To: T10 Technical Committee
 From: Steven Fairchild, HP (steve.Fairchild@hp.com)
 Date: ~~14 October~~^{3 November} 2003
 Subject: SAS Discover Algorithm Modification

This proposal addresses two issues with the SAS Discover process as described in SAS 1.0.

Figure 1: Edge expander device set x0xx

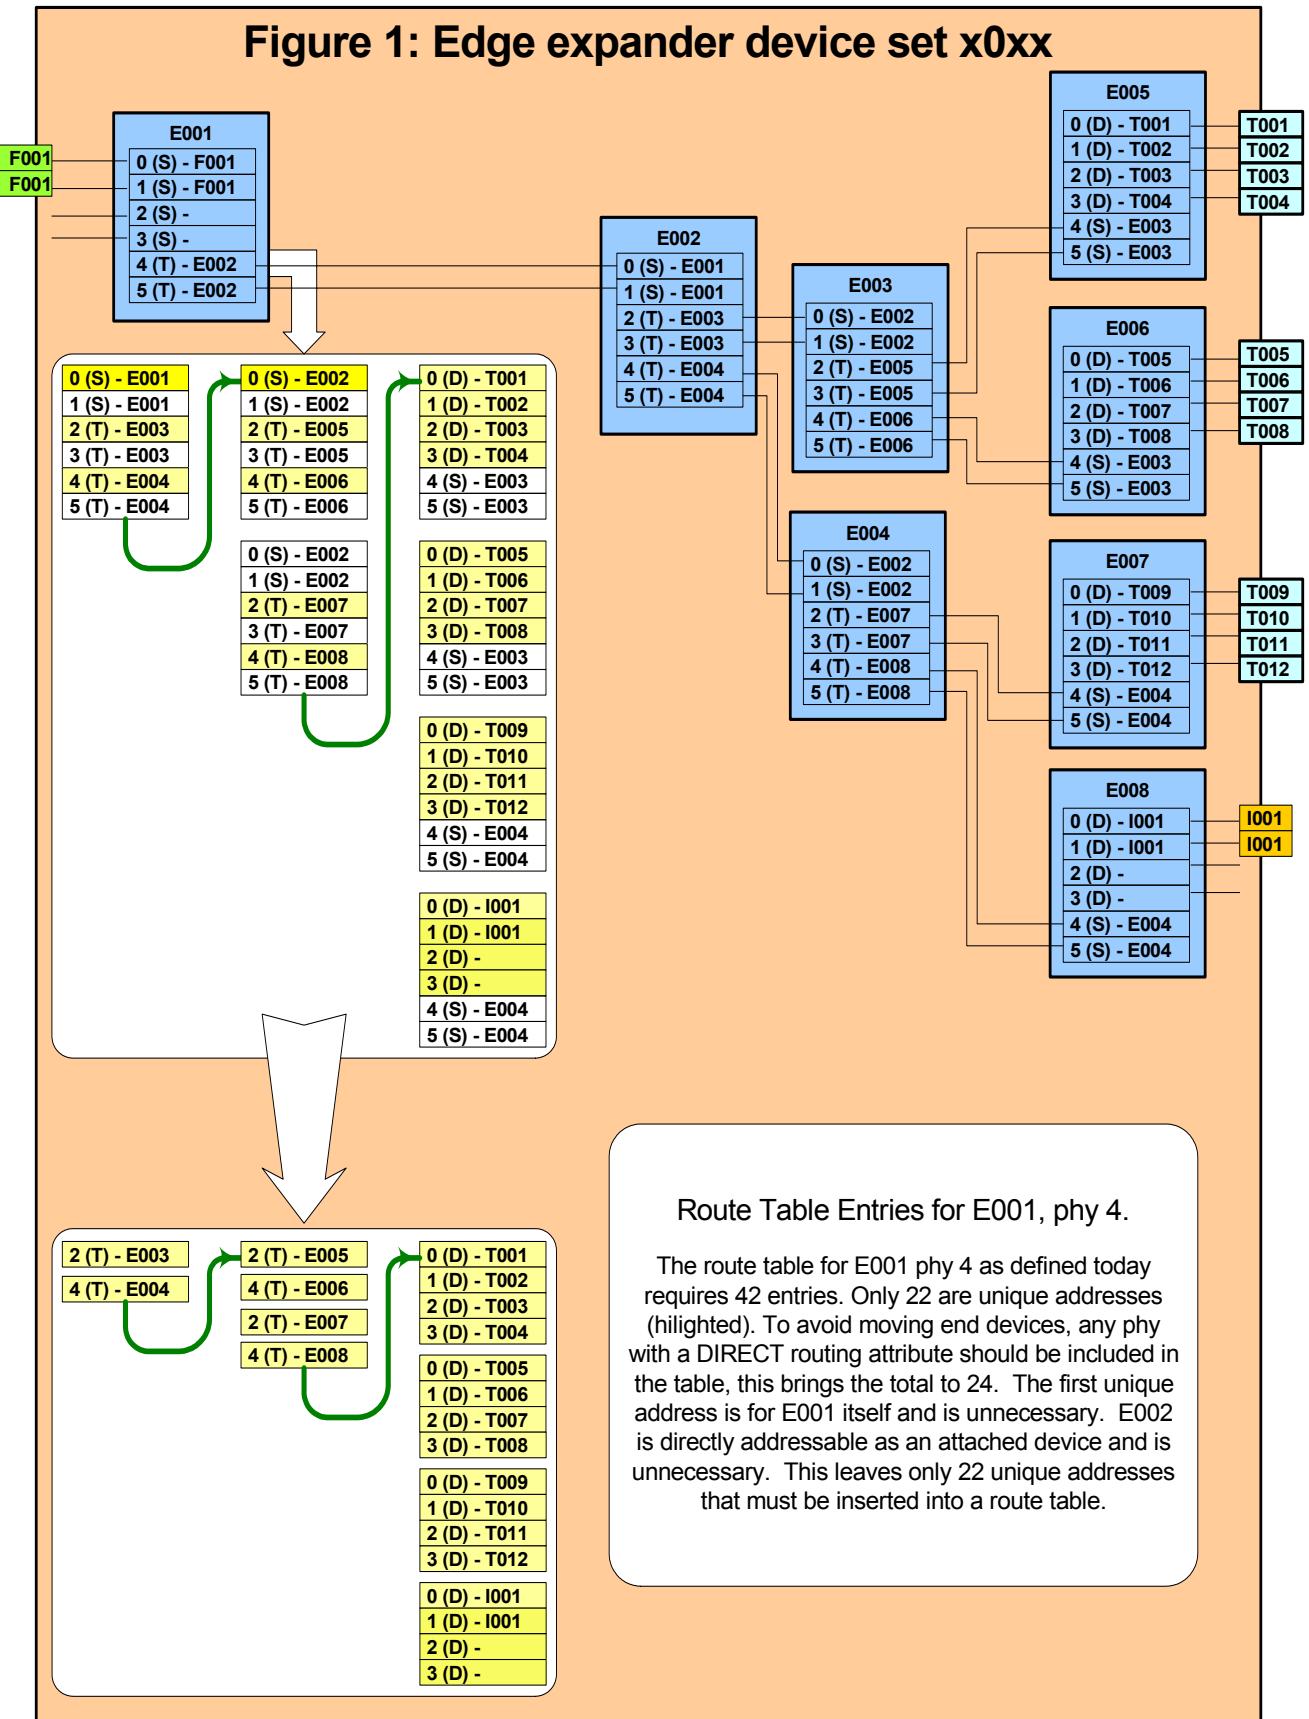
The diagrams at the end of this proposal illustrate the change in the route table entry layout.

Figures 1, 2 and 3 describe a topology that has two, edge expander device sets connected with a fanout expander. Each figure shows the original route table contents and the optimized route table contents.
